INCH-POUND
 MIL-C-15430J(SHIPS)
 AMENDMENT 4
24 April 1989
 SUPERSEDING
 AMENDMENT 3
 16 June 1983

CONDENSERS, STEAM, NAVAL SHIPBOARD

This amendment forms a part of MIL-C-15430J(SHIPS), dated 19 June 1974, and is approved for use by the Naval Sea Systems Command, Department of the Navy, and is available for use by all Departments and Agencies of the Department of Defense.

SH 10476

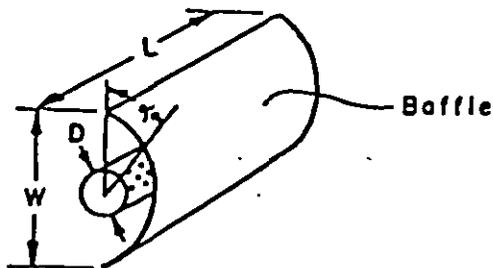
3.2.17.3.1.2: Delete and substitute:

"3.2.17.3.1.2 Unless otherwise approved by the drawing review agency, the pressure/velocity reducing configuration shall be in the form of the perforated pipe and baffle which shall have the following general configuration:

Note: Other pipe and baffle configurations may be used provided they meet the guidelines below.

Perforations in the pipe shall be such that the steam will exit evenly along the pipe length and shall be located such that the steam emerging from the perforations will strike the baffle. To ensure this, the minimum angle " α " shall be 30 degrees where α is the angle from the outermost row of perforation to the edge of the baffle as measured from the center of the pipe. Maximum orifice or perforation size shall be 3/8 inch diameter. The location of tubes with respect to the baffle opening is optional.

- (a) For auxiliary exhaust steam and other connections treated like the auxiliary exhaust steam connection, the area $L \times W$ shall be such that the average velocity of the steam when expanded to a 29 inch vacuum (referred to a 30 inch barometer) and passed through this area shall not exceed 250 feet per second (ft/s) or 750 ft/s if the impingement tubes of 3.2.11.1 are installed between the connection baffle and the tube bundle and the requirements of 3.2.11.1 are satisfied with respect to the connection baffle exit. For the auxiliary exhaust assembly, the vendor shall justify the structural adequacy of the design by submitting a vibration analysis to the drawing review agency for approval. Baffles which are required to protect the condenser shell, tubes, or other internals from impingement by auxiliary exhaust steam shall be considered part of the auxiliary exhaust assembly and shall be included in the vibration analysis.

- (b) For the steam dump, "L" shall be as nearly equal to the effective tube length as possible, allowing for shell neck where fitted and differential expansion between the shell and steam dump pipe and "W" shall be at least three times the steam pipe diameter "D". The impingement tubes of 3.2.11.1 shall be installed between the steam dump baffle and the tube to the steam dump baffle exit. Baffles required to protect the shell, tubes, or other condenser internals from impingement of dump steam shall be considered part of the steam dump assembly and shall meet the design requirements noted below. For the steam dump assembly, the vendor shall justify the structural adequacy of the design by submitting the following to the drawing review agency for approval:

- (1) Vibration analysis.
 - (2) Fatigue analysis (in accordance with the ASME Boiler and Pressure Vessel Code, Section III, Subsection NB-Class 1 components) due to thermal and pressure loads for the number of operating cycles specified (see 6.1.1). Operating cycles shall be based on the steam dump design operating temperature and pressure (see 6.1.1).

Multiple parallel pressure/velocity reducing configurations may be used provided the sum of the individual areas and the sum of the individual lengths satisfy the relationships of (a) or (b) as applicable."
